CITY OF HANOVER
PLANNING COMMISSION MEETING
DECEMBER 17, 2018
AGENDA

SUBJECT: **Hanover Cove** for (1) Rezoning; (2) Planned Unit Development; and (3) Preliminary Plat

As requested, we have reviewed the revised Hanover Cove preliminary plat documents as prepared by Duininck, dated November 16, 2018, and we offer the following comments:

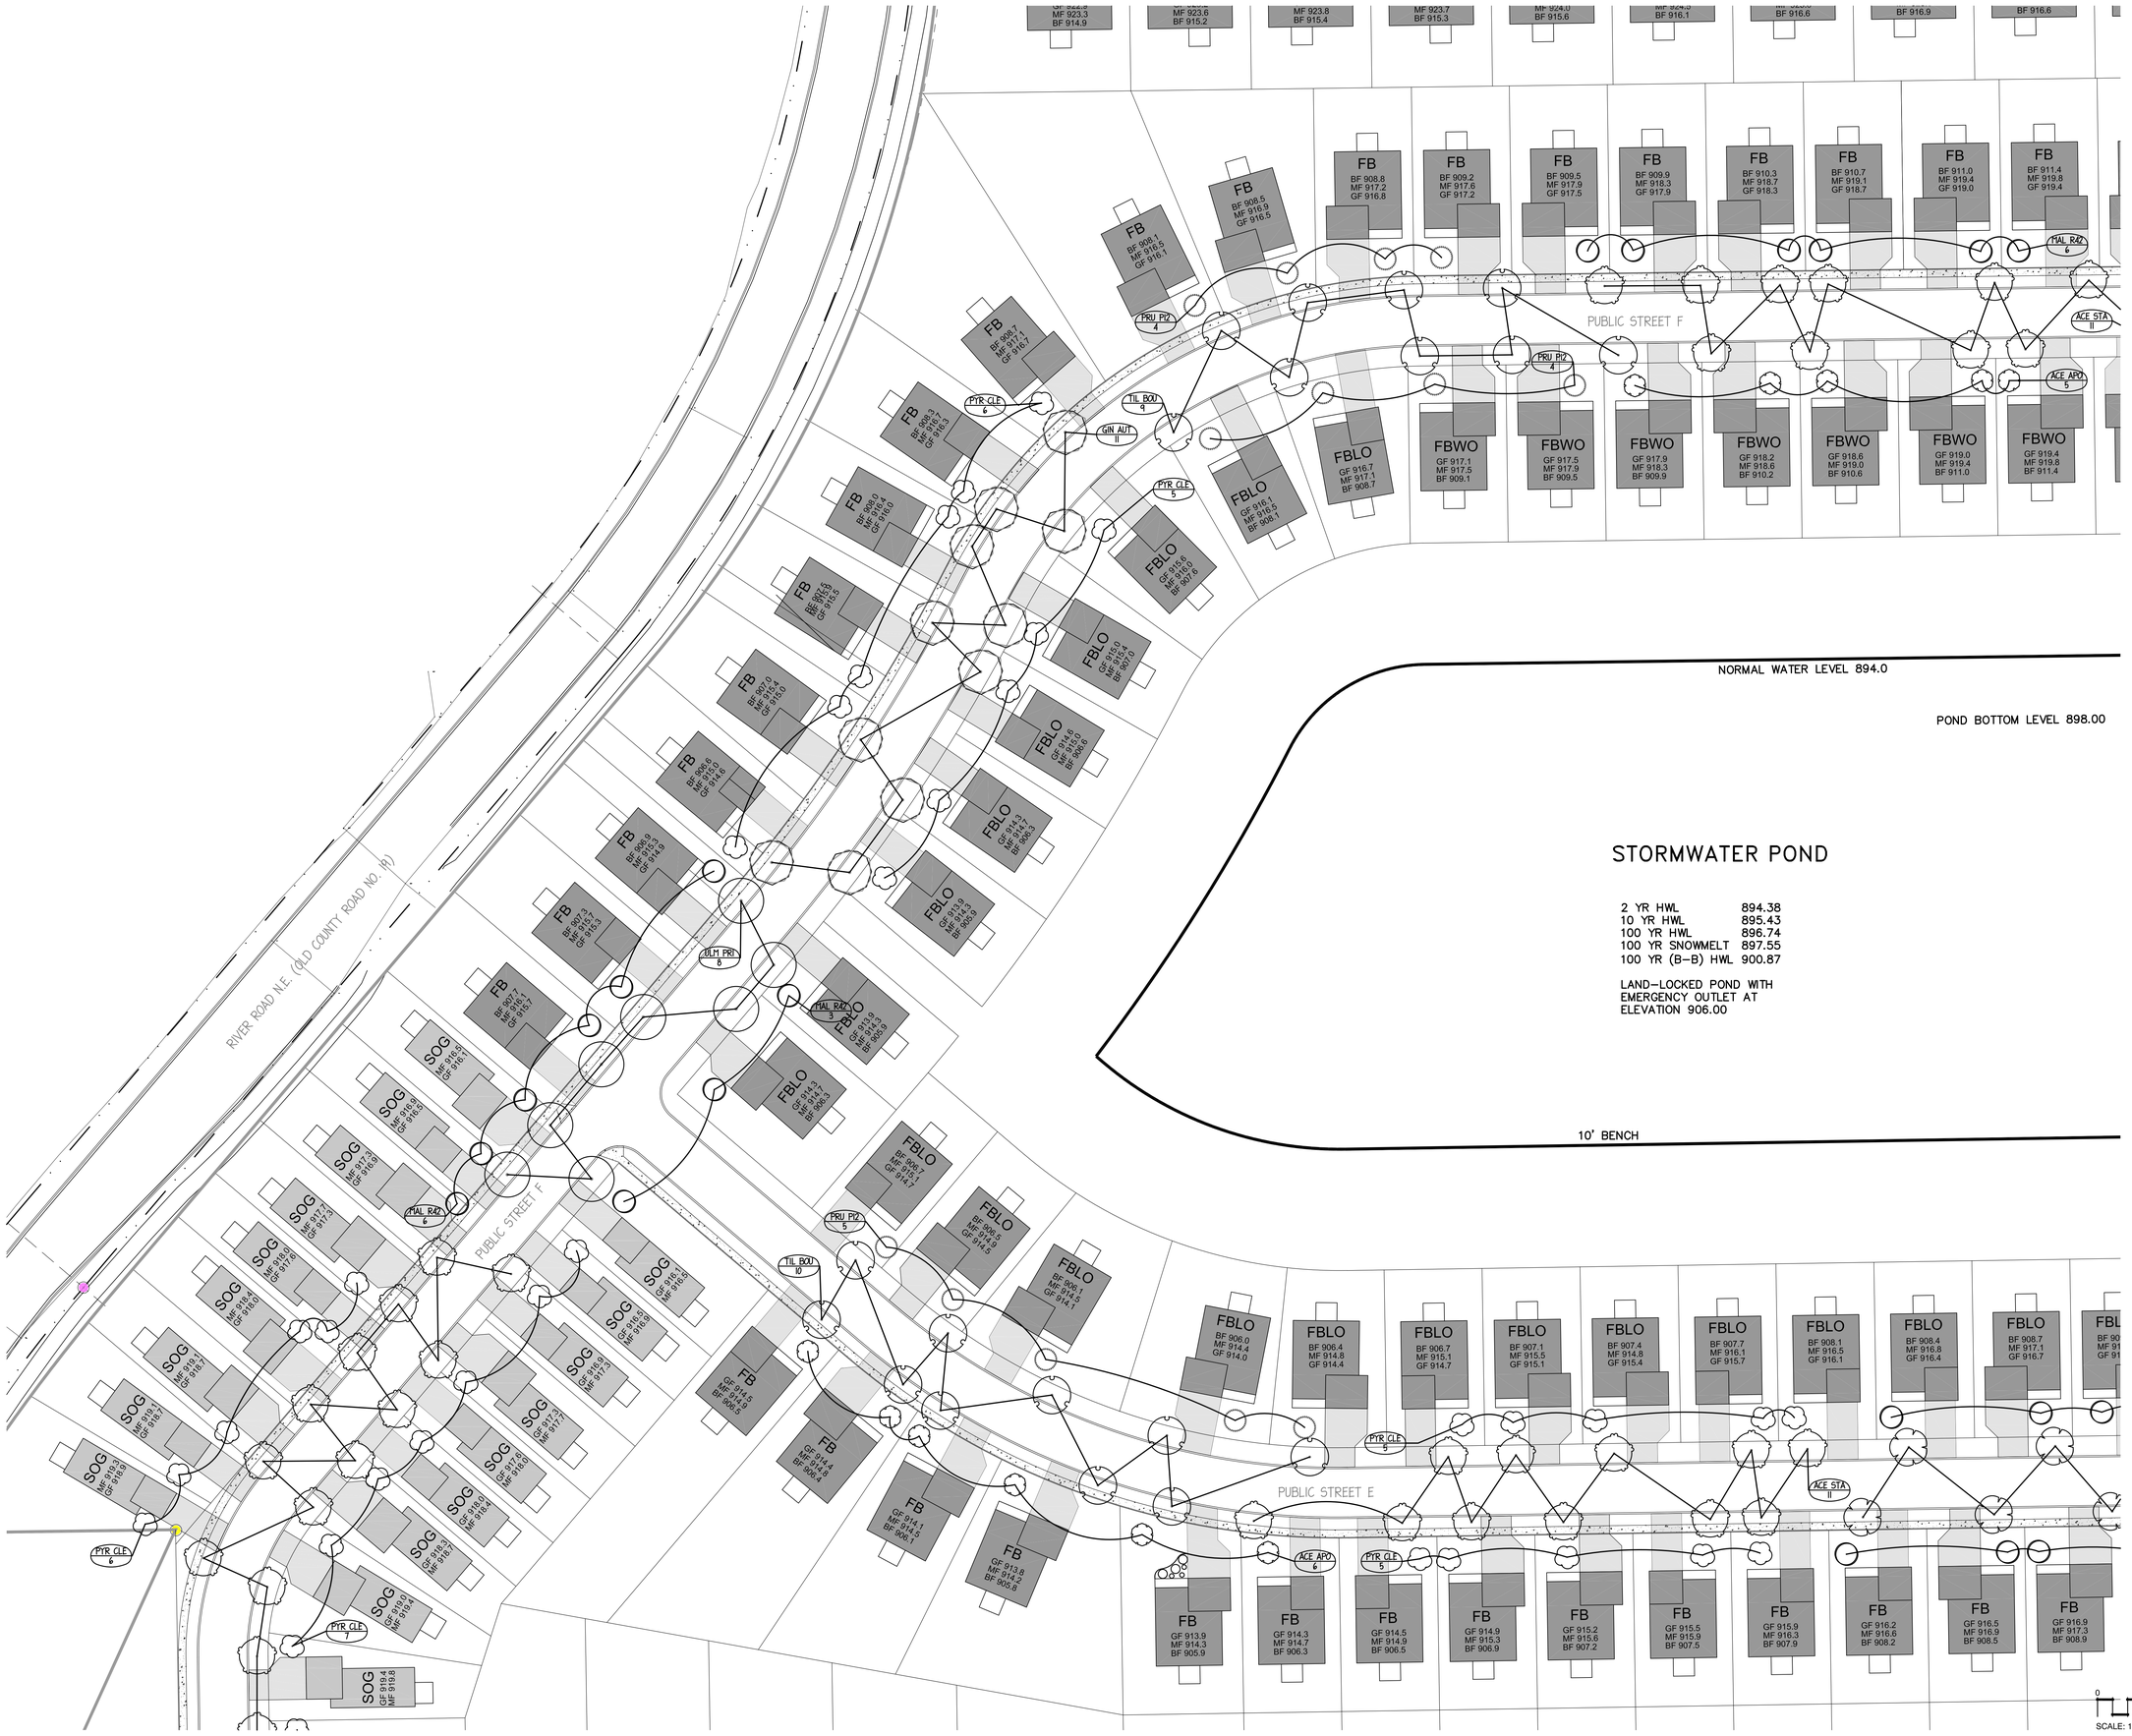
Sheets LA1 through LA5 contains the proposed landscaping plan. The landscaping plans generally identify 1 tree per lot, where the ordinance requires 2 trees per lot. In addition, additional information is required to review conformance with tree preservation requirements as noted in the City Planner's memo.
